H. B. ROBINSON STEAM ELECTRIC PLANT, UNIT NO. 2  
DOCKET NO. 50-261 / RENEWED LICENSE NO. DPR-23

**RESPONSE TO REQUEST FOR ADDITIONAL INFORMATION REGARDING LICENSE  
AMENDMENT REQUEST TO REVISE REACTOR COOLANT SYSTEM PRESSURE AND  
TEMPERATURE LIMITS**

**REQUEST FOR ADDITIONAL INFORMATION  
LICENSE AMENDMENT REQUEST  
REVISION OF REACTOR COOLANT SYSTEM PRESSURE AND TEMPERATURE LIMITS**

# **H.B. Robinson Unit 2 Cylindrical Shell Pressure- Temperature Limit Curve Applicability Check and Reactor Vessel Nozzle Pressure-Temperature Limit Curve Development for Extended Plant Operation**

**Figure 1:** Comparison of H.B. Robinson Unit 2 50 EFPY Inlet Nozzle P-T Limits and Cylindrical Shell P-T Limits

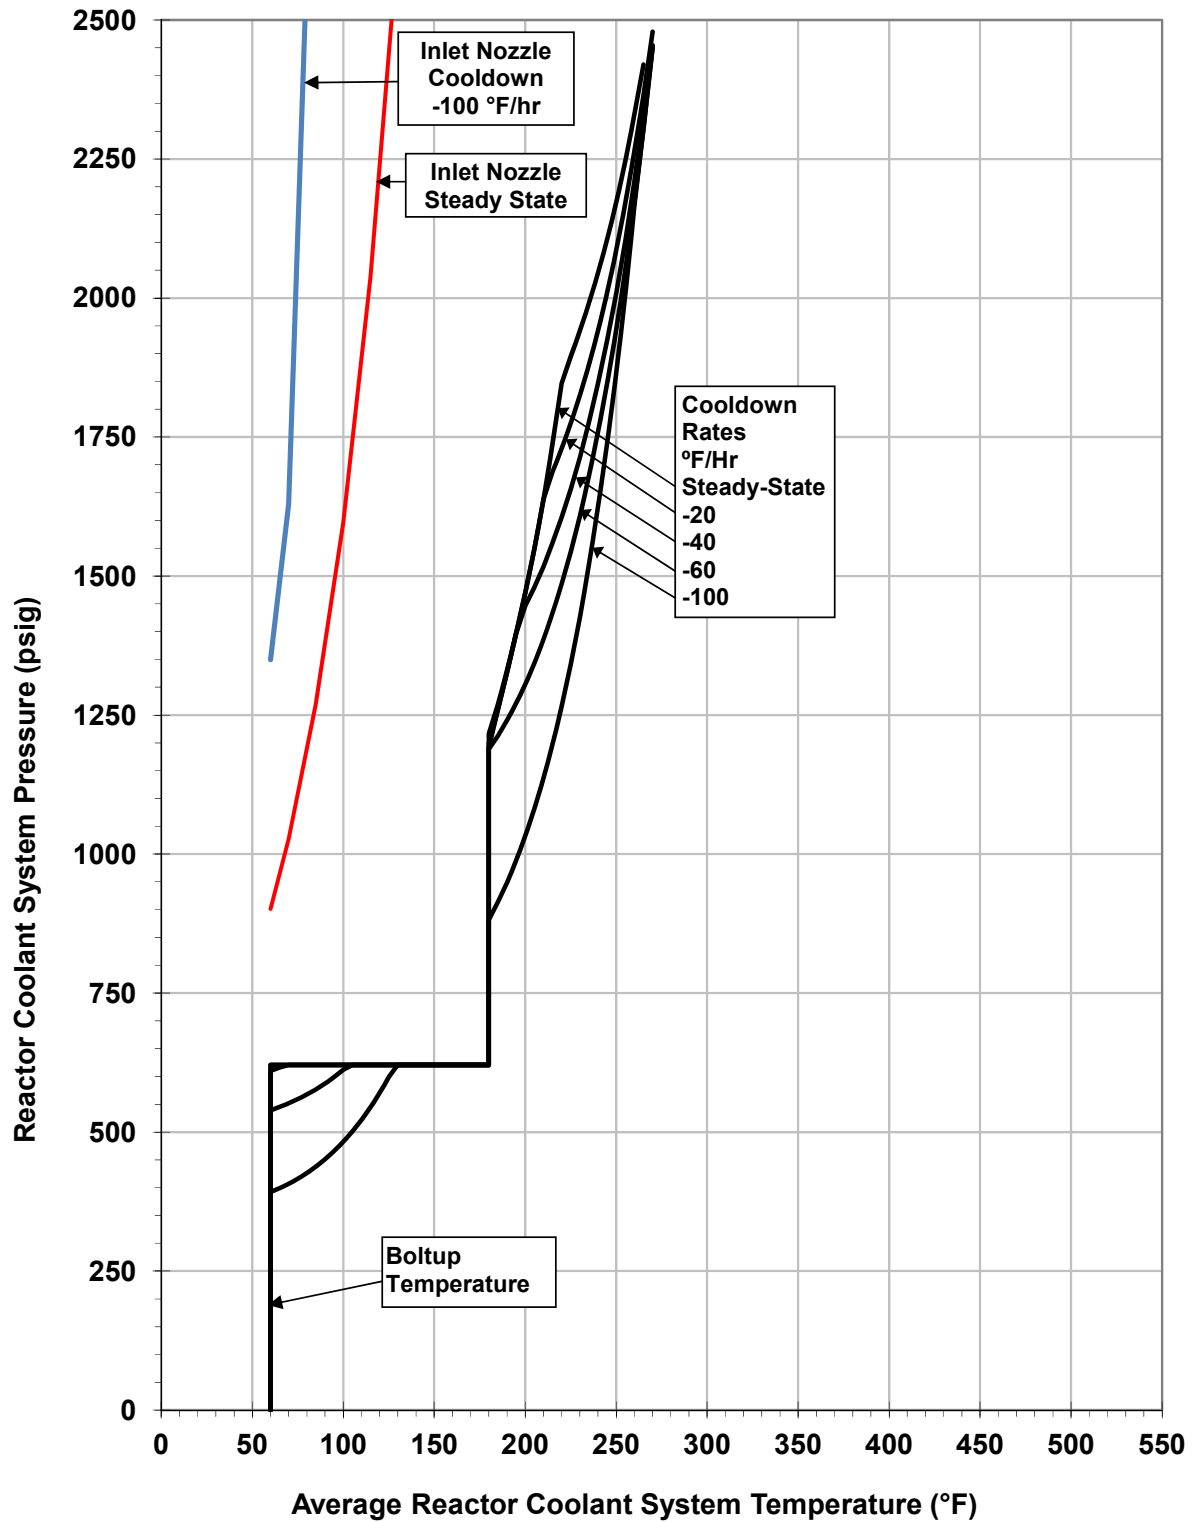
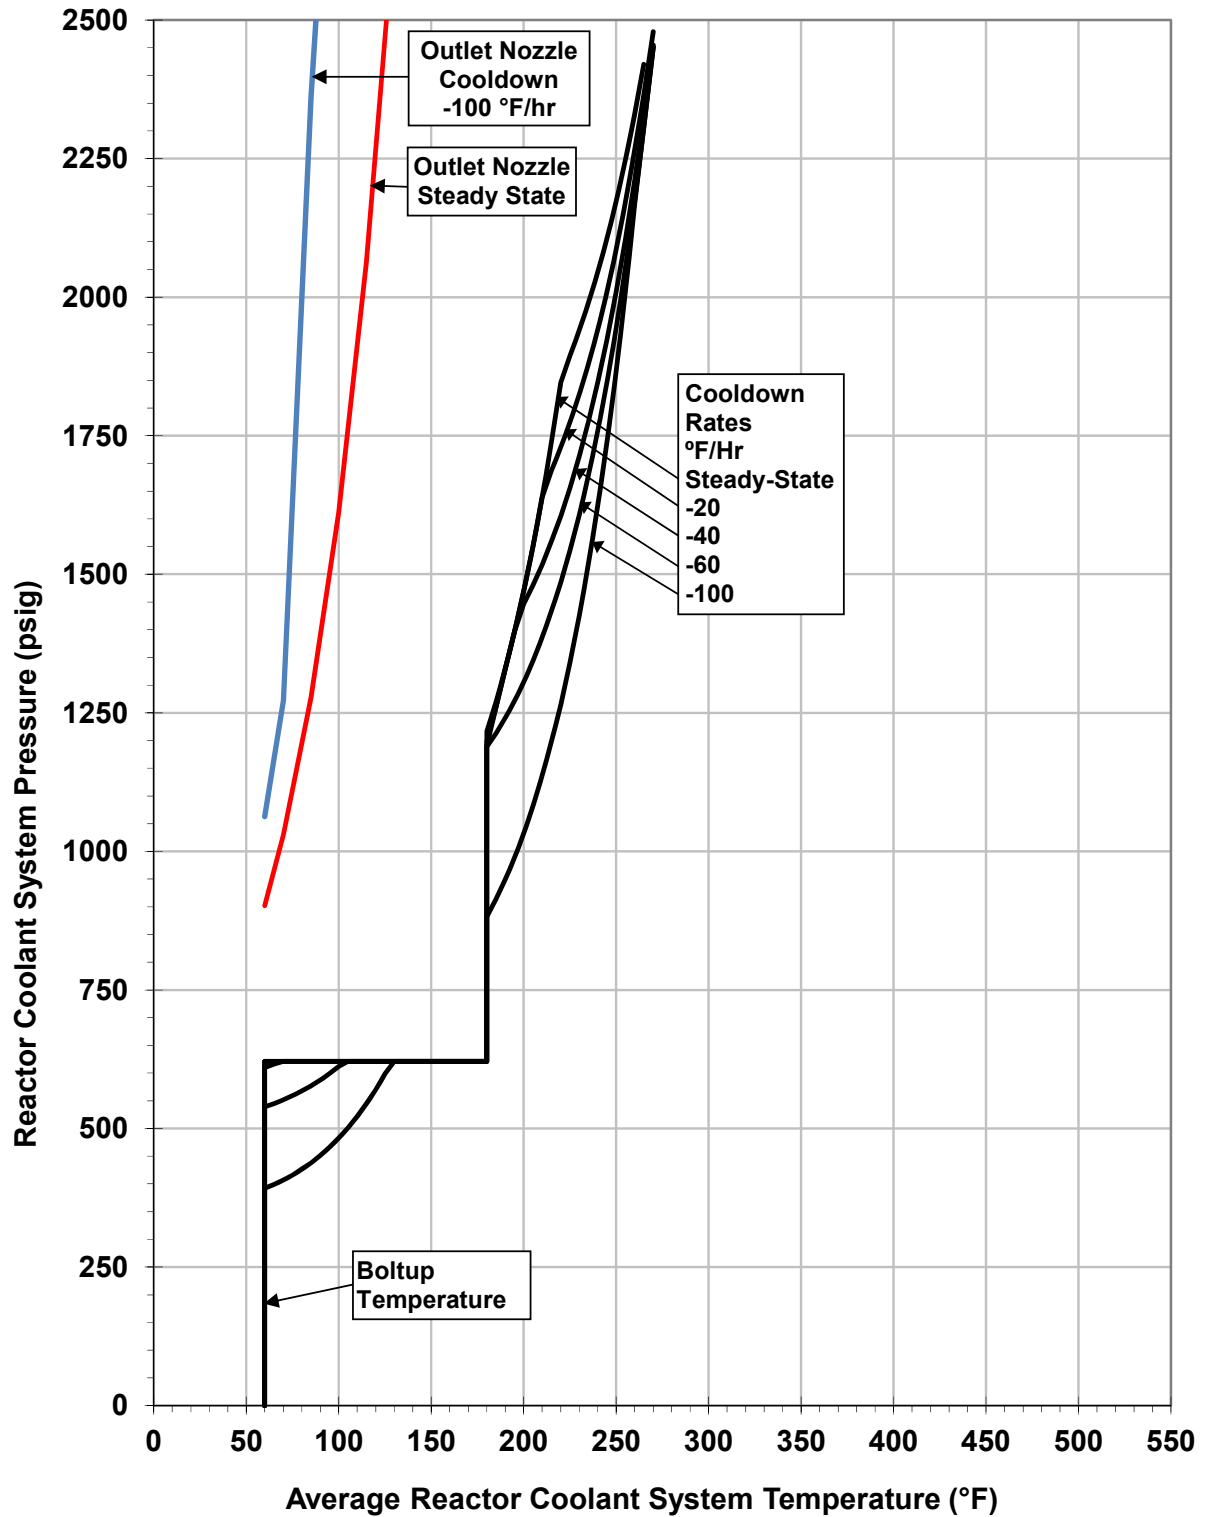
Therefore, the staff requests the licensee to provide P-T limit calculations for the Robinson RPV inlet and outlet nozzles or otherwise demonstrate how the P-T limit curves developed for 50 EFPY in WCAP-15827 bound all ferritic pressure boundary components of the RPV. In the P-T limit calculations for the Robinson RPV inlet and outlet nozzles, the staff requests the following to be used: 1) the ART values of the Robinson RPV inlet nozzle, outlet nozzle, and "Nozzle Welds" in Tables 16 and 17 of WCAP-15827, and 2) consideration of the stress levels in the welds that attach the Robinson RPV inlet and outlet nozzles to the RPV. Lastly, the staff requests the licensee to confirm that there are no other ferritic pressure boundary components of the Robinson RPV that need to be considered for P-T limit evaluation for the period of extended operation.

The H.B. Robinson Unit 2 inlet and outlet nozzle P-T limit curves shown in Figures 1 and 2 are based on the stress intensity factor expression discussed above; also shown in these figures are the traditional beltline P-T limits from WCAP-15827, Revision 0 [Ref. 3]. The nozzle P-T limits and the traditional beltline P-T limits are applicable to 50 EFPY. The nozzle P-T limits are provided for a cooldown rate of 100°F/hr, as well as at steady-state.

Based on the results shown in Figures 1 and 2, it is concluded that the nozzle P-T limits are bounded by the traditional beltline curves. Therefore, the 50 EFPY P-T limits contained in WCAP-15827, Revision 0 [Ref. 3] are applicable for the beltline and non-beltline reactor vessel components of H.B. Robinson Unit 2 through 50 EFPY based on the technical evaluations contained herein.
